NOTICE OF A TYPE II DECISION ON A PROPOSAL IN YOUR NEIGHBORHOOD

CASE FILE NUMBER: LU 19-244401 DZ – NEW MULTI-DWELLING RESIDENTIAL AT N. MONTANA & JESSUP

Case Type: DZ – Design Review
Procedure: Type II – an administrative decision with appeal to the Design Commission.

C2.2 OVERALL PROPOSED SITE PLAN / SITE LIGHTING PLAN

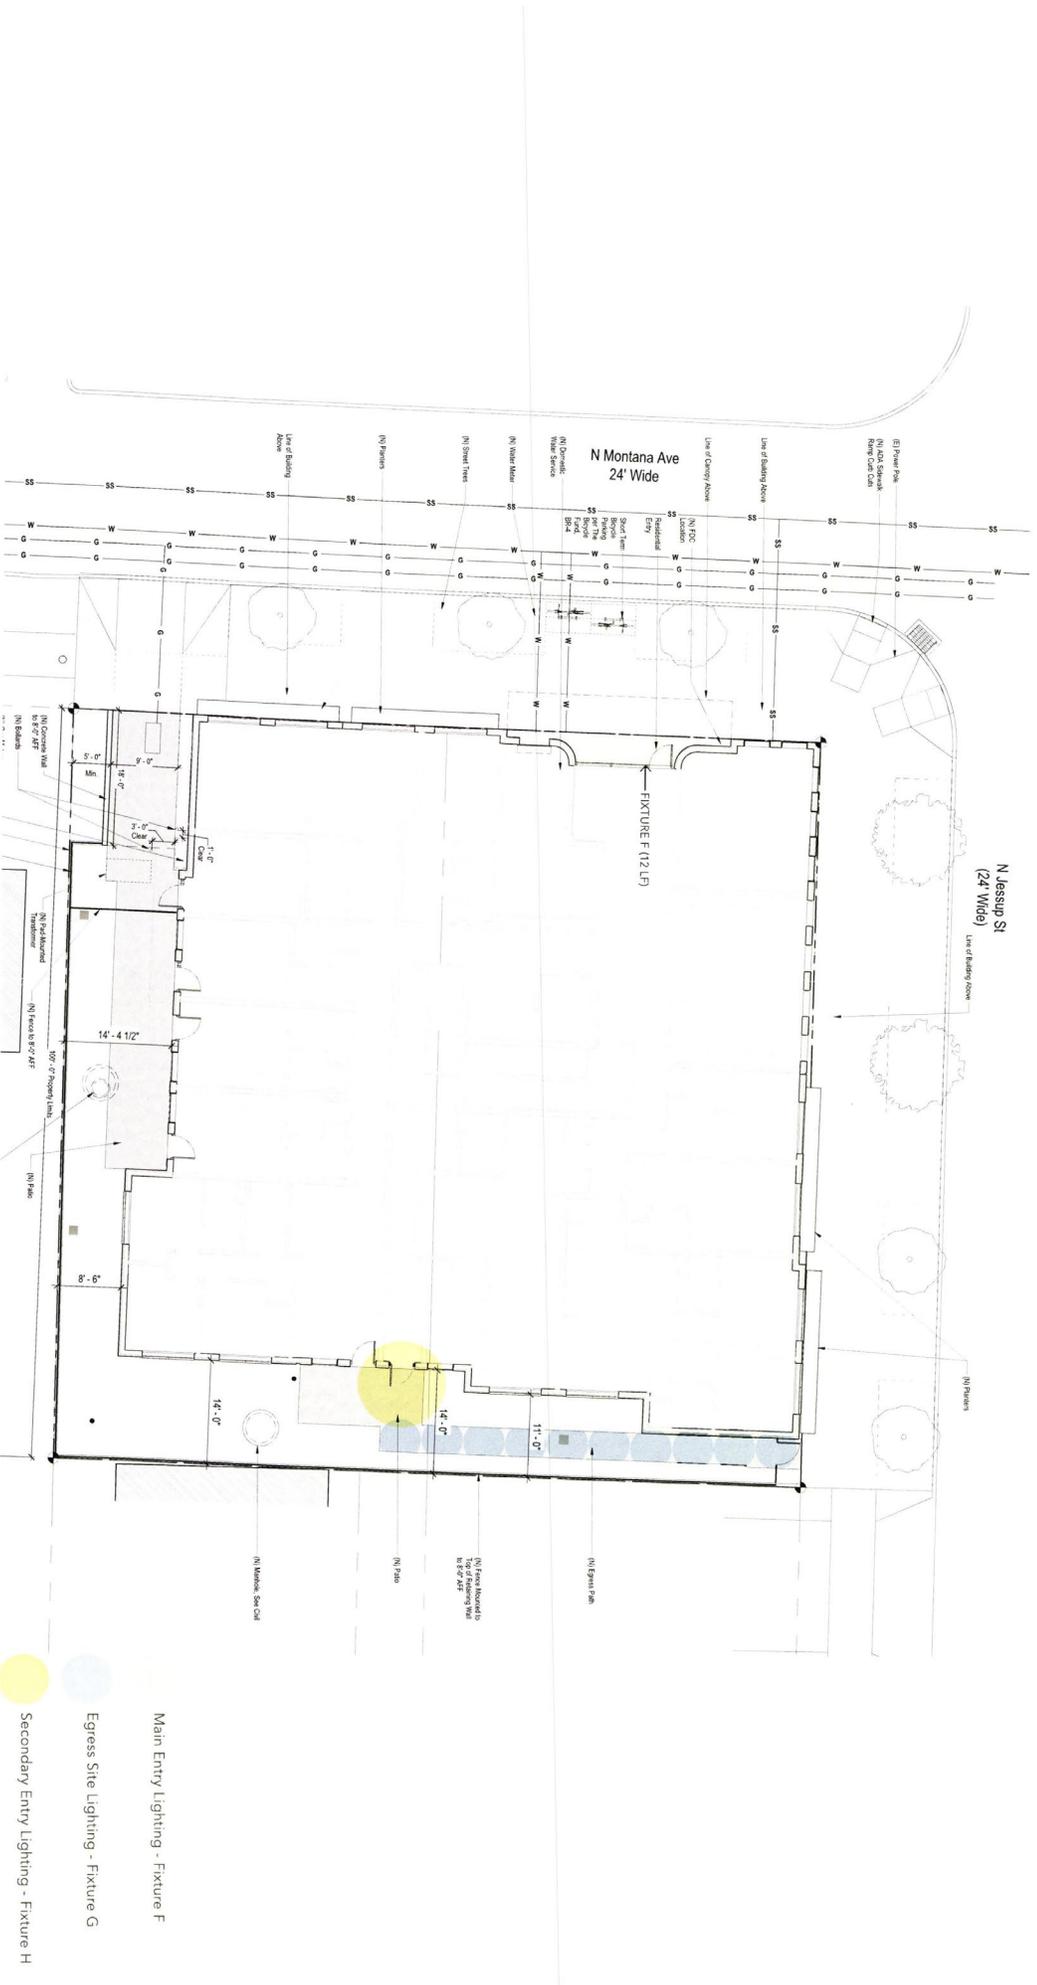
- No lighting is proposed at the loading space on the south side of the building, and now windows from the adjacent residential unit open onto this space to provide ambient lighting. This space will end up being very dark, particularly with its deep recess from the sidewalk. A light fixture should be placed in this area, as well, to provide illumination. Fixture “H”, which is only proposed in one location at the east elevation, should also be placed near the egress door to the loading area. This will help to provide additional illumination in this area, and the narrow beam-spread will prevent significant impacts on the adjacent single-dwelling residential property. This fixture could be added through a condition of approval.

Findings: The proposed transformer at the southwest corner of the site is not screened from the street with either landscaping meeting the L2 landscaping standard or a fence meeting the F2 fence standard, as required by this screening standard. This could be resolved by shifting the fence dividing the loading area and the outdoor patios further to the west to screen the transformer. Gates could be added to the fence to allow access to the transformer.
